Delegated Report

Householder Planning Application

Planning Application No: 20231119

Description: Installation of a dropped kerb. Removal of grass verge to gain access to driveway at front of property.

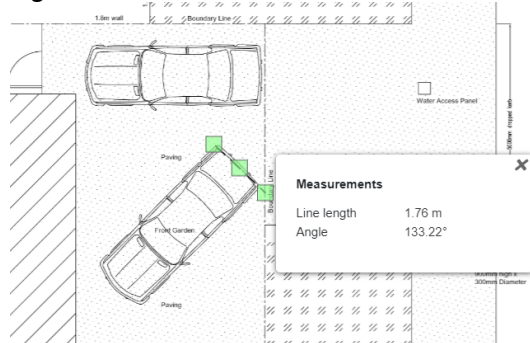
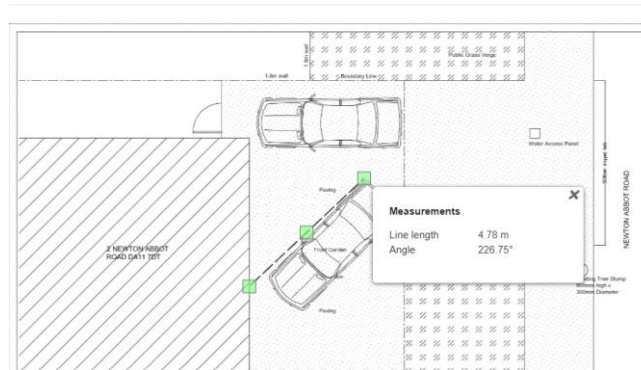
As presented, I can only recommend refusal. The Kent Design preferred parking space is 5 metres deep by 2.5 metres wide, increasing to 2.7 metres wide adjacent to an enclosing boundary. (KCC SPG4). The absolute minimum would be 4.8 metres long by 2.4 metres a standard size bay in many documents. Here I measure the bay is some 4.7 metres long.

Kent County Council may permit a crossover for a single vehicle to park on the property parallel to the carriageway, but given the distance from the carriageway, this would have to be proven by a tracked swept drawing for a large family saloon vehicle, BMW 5i series or similar.

However, given any such permission would be difficult to enforce the proposal would need to be redesigned for a single vehicle with a soft planted landscaping that can be conditioned to be maintained, which may be difficult or impossible to achieve.

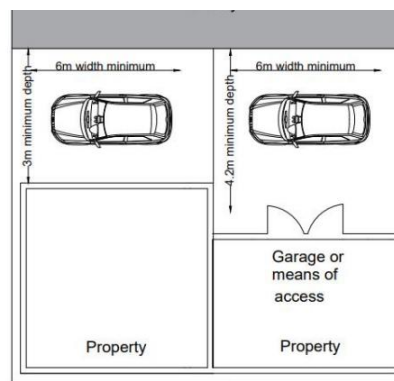
Whilst the space leading to the side gate is only 1.8 metres wide., so well below requirements and any car parked would obstruct access to the gate. Similarly, the vehicle parked at an angle does not relate to a standard size parking space, being some 1.8 metres wide x 4.8 metres deep.

Proposed

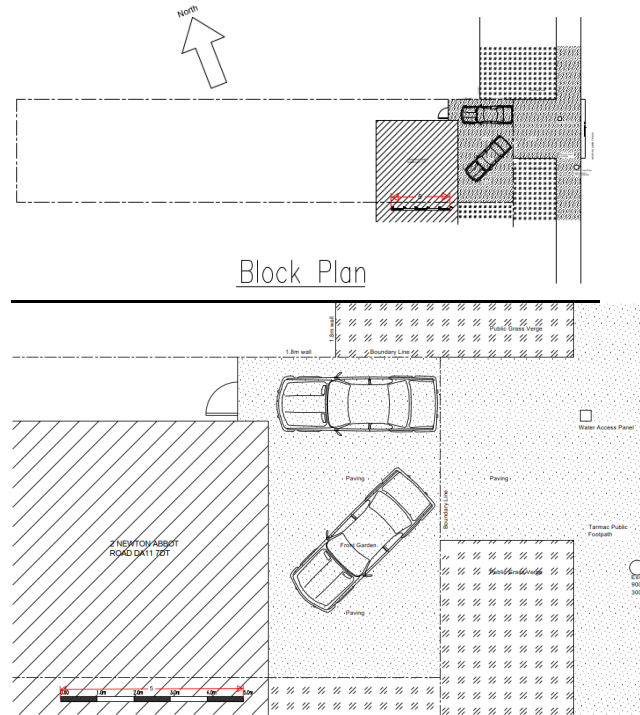
The proposal would seek to remove a 5m section of the grass verge and would involve removing all of the soft landscaping and replacing it with hard paving to facilitate off road parking for two vehicles. The driveway will have a depth of some 4.7m and a width of 8.7m.

The hardstanding is insufficient and contrary to the Kent County Council's parking standards (SPG 4) which states a space should have a minimum depth of 5m and a minimum width of 2.5m. It is evident that adequate parking cannot be achieved to the front of the property and as a result - as can be seen with the

existing parking arrangement – there will be an overhang onto public highway land which is unacceptable. As such the application is contrary to the minimum depth stated in KCCs parking standards (SPG 4) and cannot be supported on highway grounds.
